Stacy L. Balzer
Operating Director
Service Engineering Operations
Ford Customer Service Division

July 6, 2023

**SUBJECT: NEW VEHICLE DELIVERY HOLD
Safety Compliance Recall 23C18**
Certain 2019-2023 Model Year Ranger
Certain 2023 Model Year F-250 Super Duty
Certain 2022-2023 Bronco Vehicles
Install New TREAD Label

FIGURE 1

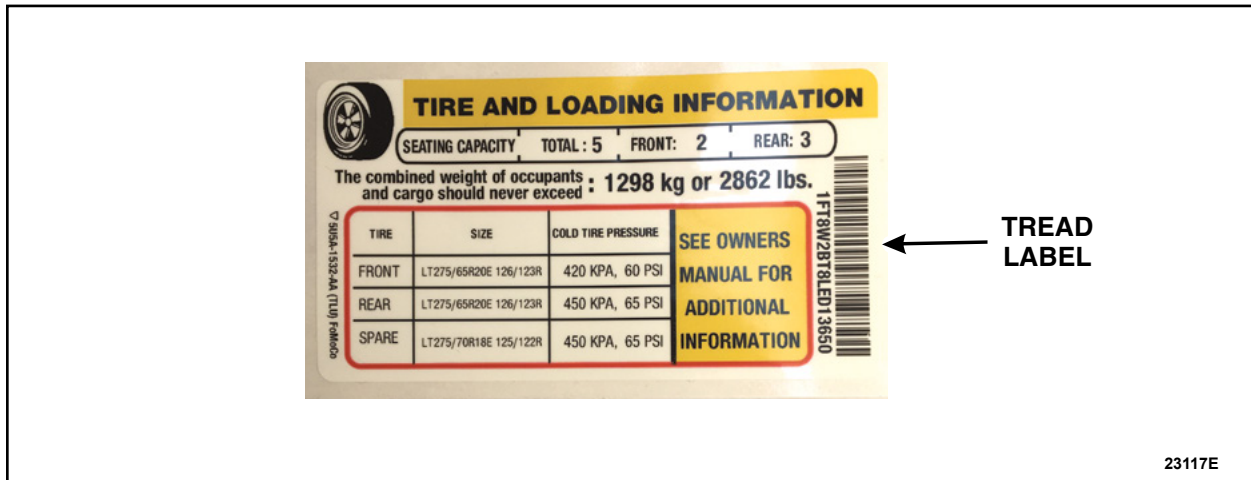
2. For In-Stock units, open the drivers door to see the TREAD label on the door jamb. Confirm the VIN on the *new* label matches the VIN on the vehicle. See Figure 1.

- If the VIN does not match, contact the SSSC before proceeding with this program to order a *new* VIN specific label.

FIGURE 2

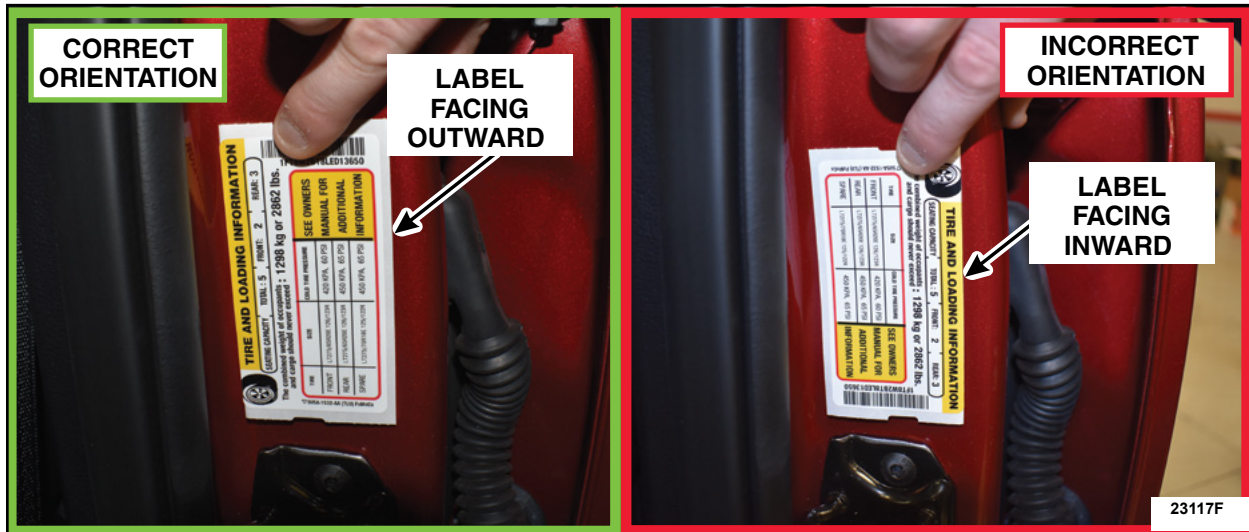
3. Using a clean cloth and isopropyl alcohol, remove any residue from on and around the original label on the B-Pillar.

- Note the orientation of the original Tire and Loading Information (TREAD) label.
- Install the *new* label over the original TREAD label, in the same location and orientation. See Figure 2.

FIGURE 1

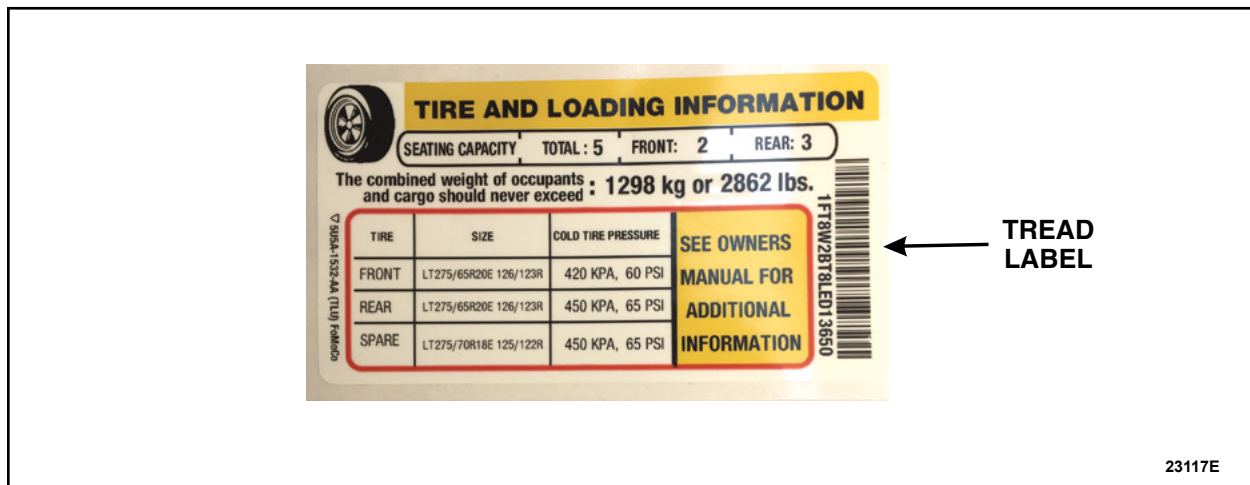
2. Confirm that the VIN on the *new* label matches the VIN on the vehicle. See Figure 1.

- If the VIN does not match contact your dealer.

FIGURE 2

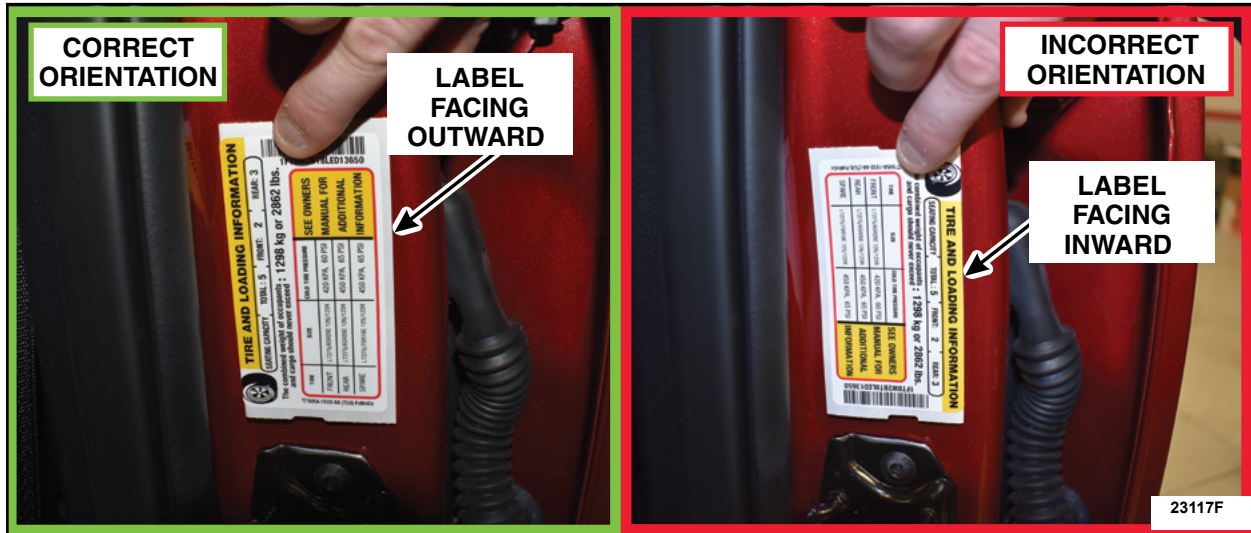
3. Using a clean cloth and isopropyl alcohol, remove any residue from on and around the original label on the door jamb.

4. Note the orientation of the original label.

5. Install the *new* label **OVER** the original label, in the same location and orientation. See Figure 2.
